Seattle Design Commission

MINUTES OF THE MEETING

January 17, 2008

Projects Reviewed

Figure 1: Pedestrian overpass concept design.

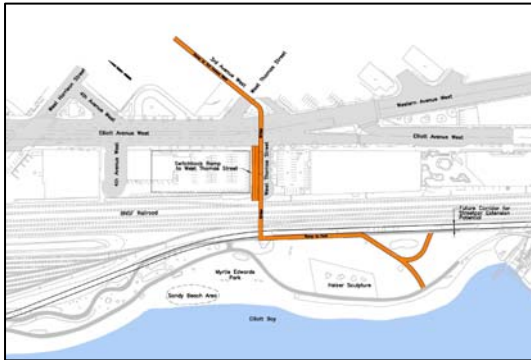
The Commission thanks the team for their presentation, and while the Commission supports this project as a whole, it unanimously does not approve schematic design of the bridge alignment based on the following comments:

- Concern about moving forward into future design phases if this is the design due to current funding situations
- Concern over the level of detail presented, making it hard to review and feel it is lacking compared to past presentations. Contents shown a year ago offered more detail than presentation materials today.

- Regret that efforts put into preparing materials for the artist weren't brought to the table to understand the current level of design and detailing
- Concerns over crossing over Elliott, yet also understand the need to avoid a signalized crossing at Elliott.

- Concerns about future phases of the project without the accessible access point at Elliott
- Images of how the structure crosses Elliott are critical to understanding the project and the urban design merits, and must be displayed

- Suggest reconsideration of the phasing that includes phasing the Elliott crossing rather than the Elliott access point
- Great concerns about the safety for cyclists and pedestrians, especially at the corner intersections and 90 degree bend as the trail enters the park. Flaring, nodes, or other means of wider passage, including a belvedere or some means of respite, would add function, safety and good design

- Suggest the study of potential for simplifying the ramp alignment to the mound to avoid unnecessary kinks and cost in the project.
- The sloping mound as a starting point for the ramp is seen as a positive and unobtrusive element.

- The quality and application of utilitarian detail should achieve a higher standard than the images shown; learn from examples like the adjacent Sculpture Park.
- Utilize this as an opportunity to complement the Heizer Sculpture.
- If there is not going to be a multi-use trail, then regrade is recommended.

- Walking through the images and plan, how does the overpass thread over the potential streetcar route and bike trail?
 - The bridge will extend about twenty feet beyond the trolley fence line and the ramp will be offset by the bridge centerline.

- It is hard to tell if the two girders dead-end in space, with a concrete slab beyond that.
 - Yes, they do.
- Is there a highway pass over the bridge? Will those be detailed similarly? Is there a single concrete pier?

- Is there a baseline?
- Regarding the ramp east of Heizer, could the angle be more radial with a gently curved segmented precast?
 - That would be a cast in place solution, which would not be in the budget. Yes, the team will make it more round horizontally

- There are three aspects to the overpass, which include the part where it crosses Elliott that is visually significant, where it crosses the BNSF tracks that is less visually significant, and where it comes down to Myrtle Edwards Park. The path was created for bike ramps with the idea to cross Elliott and land gracefully in the park. However, pedestrians now cannot access a graceful arc across Elliott (steel with curve). Would value engineering permit access from the west side with steeper ramps?

- On a positive note, switch from steel to concrete is okay because it models the quality of the Heizer sculpture.
- There are visibility issues in turning corners over the I-90 trail due to limited sightline. A node for respite, clearances and corners need to be incorporated.
